# CITY OF ALBUQUERQUE

**Re: Sunport Apartments  
2930 Mulberry SE  
Request for Certificate of Occupancy  
Transportation Development Final Inspection**  
Architect's Stamp dated 07-07-20 (M15-D036)  
Certification dated 09-30-22

Based upon the information provided in your submittal received 10-04-22, Transportation Development cannot approve the release of Certificate of Occupancy for the above referenced project.

#### 1 SITE PLAN

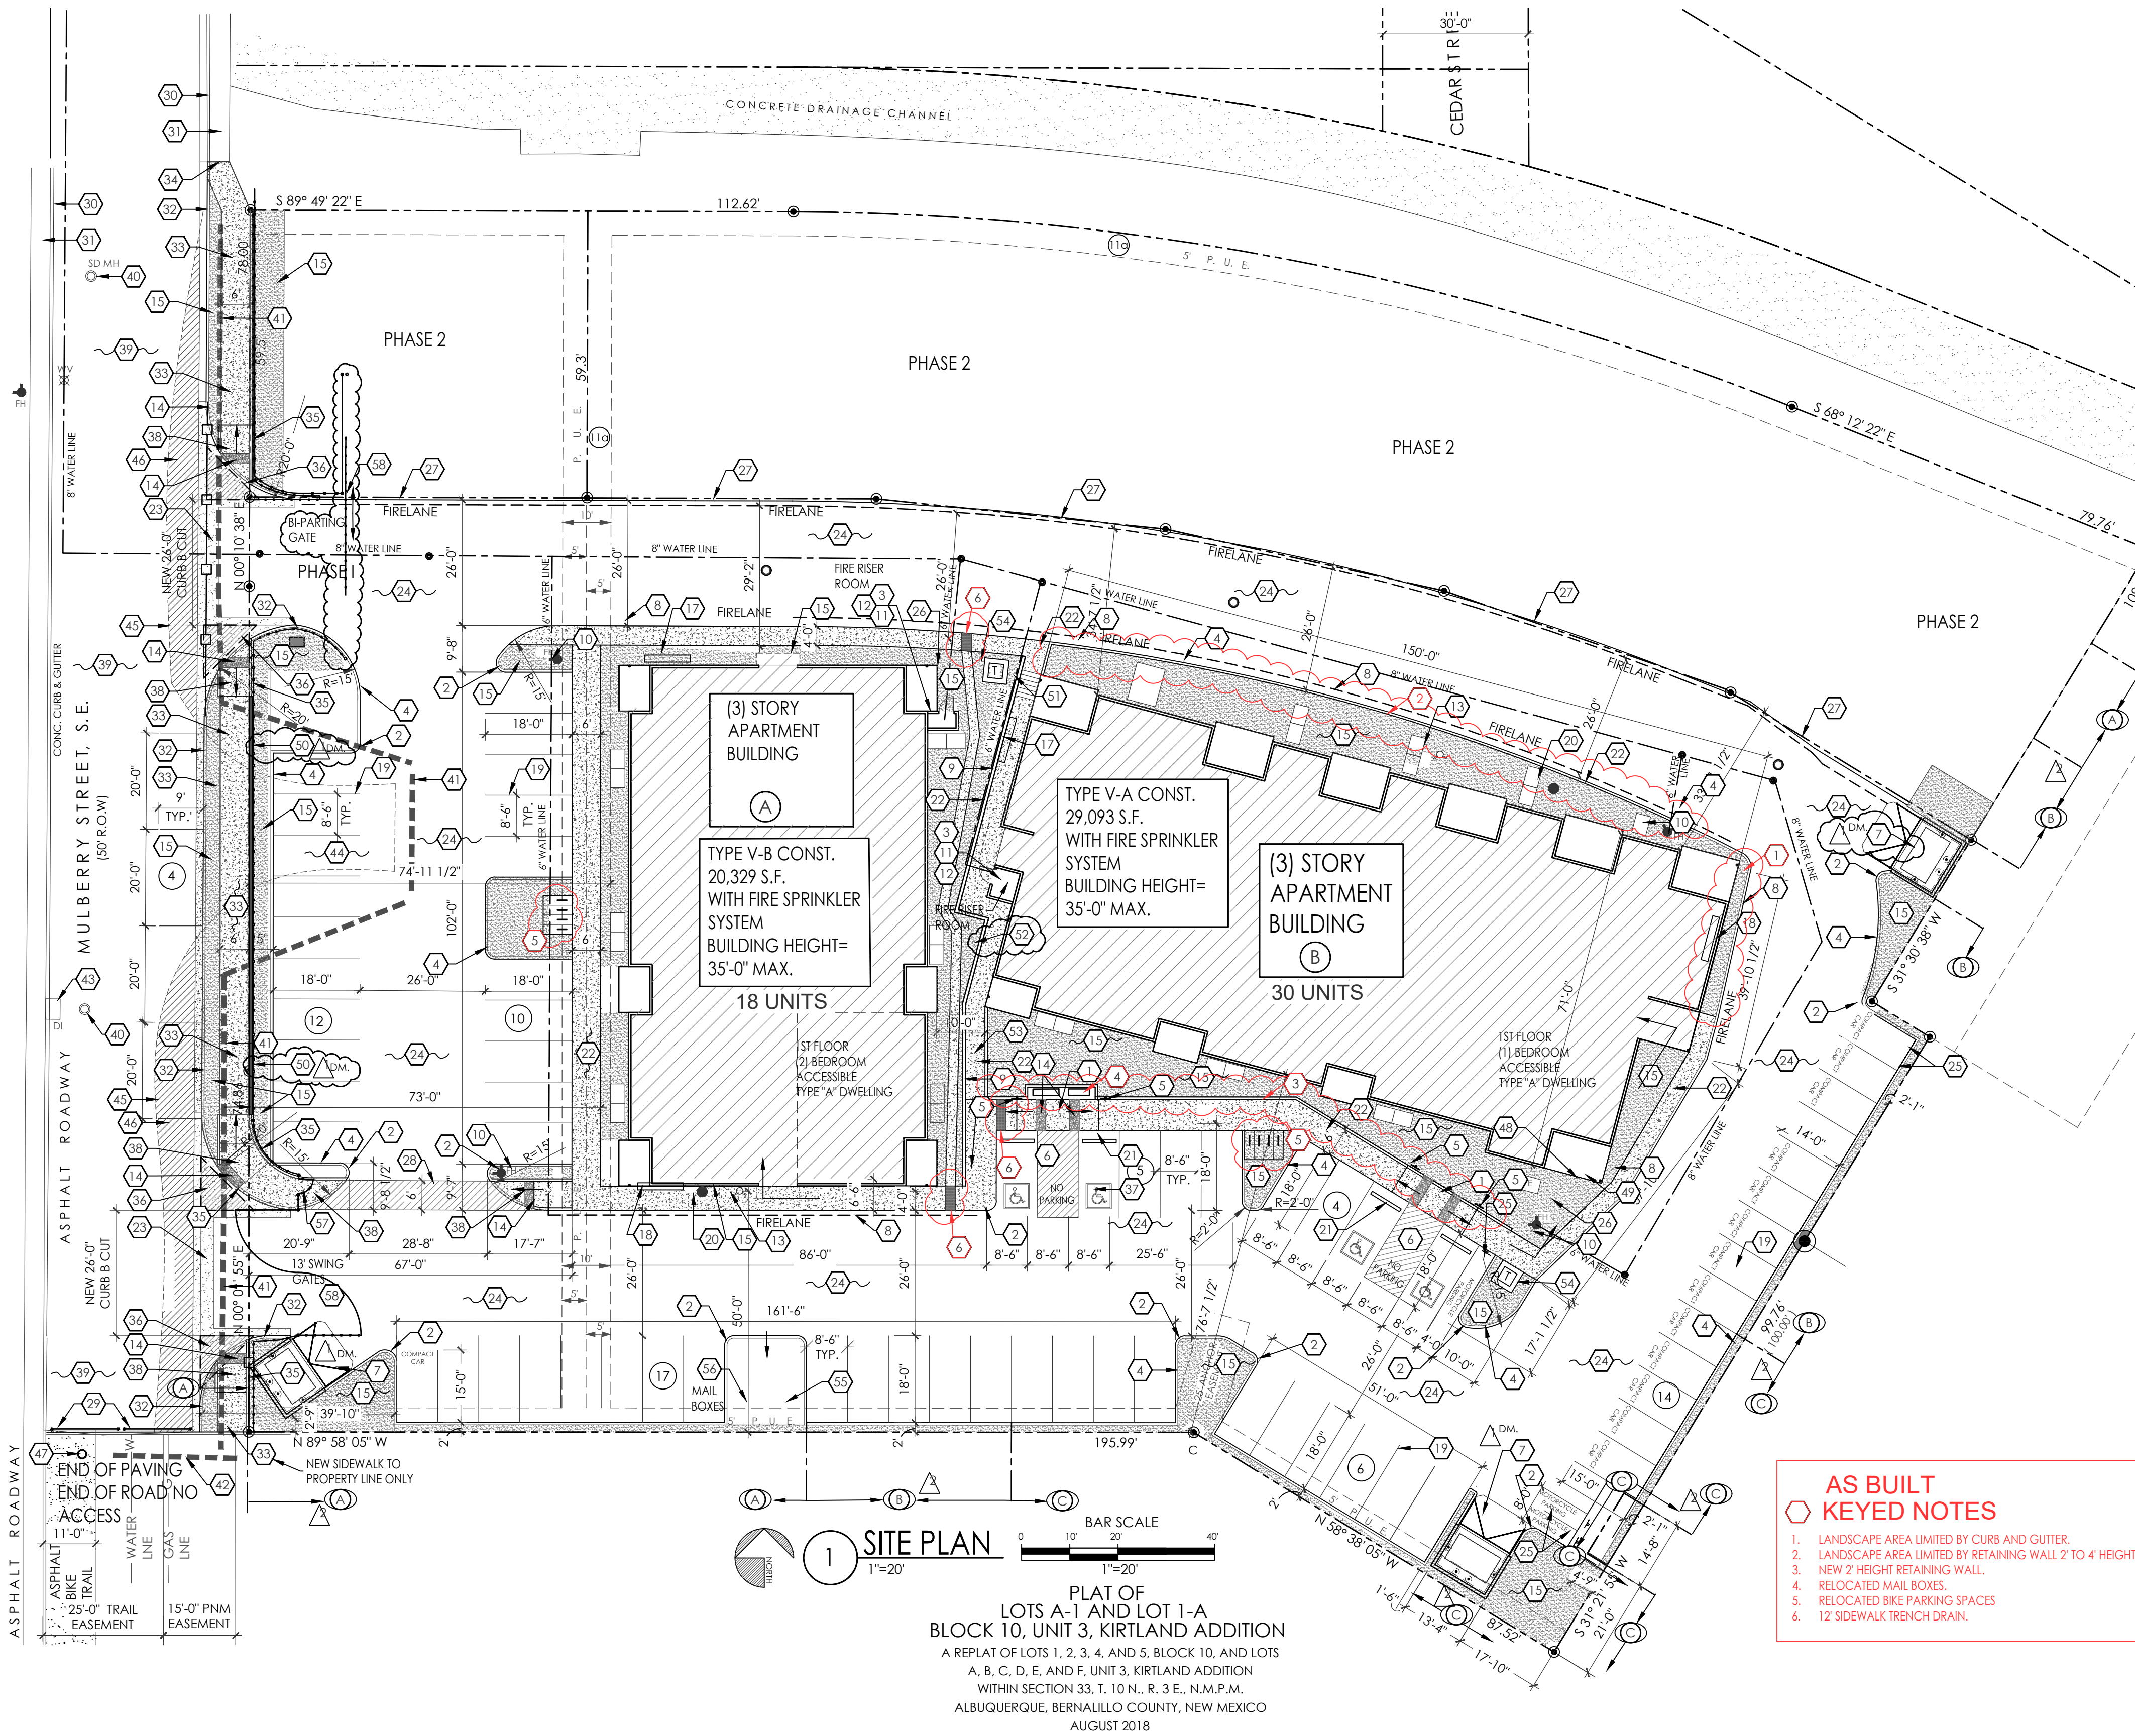
- Work order must be completed, approved and accepted by City of Albuquerque.
- Please finish the site work at the north side of the site.
- Key note 53: Per site visit, ADA ramp leads to a step, which is not acceptable. Per approved site plan the ADA pathway should lead to the building entrance. Please address this concern. See attached picture.
- Label the compact parking spaces by placing the words "**COMPACT**" on the pavement of each space.
- The pavement marking "MC" should be shown in the opposite direction for motorcycles entering the parking space.
- Please provide Van signage for one of the ADA parking spaces.
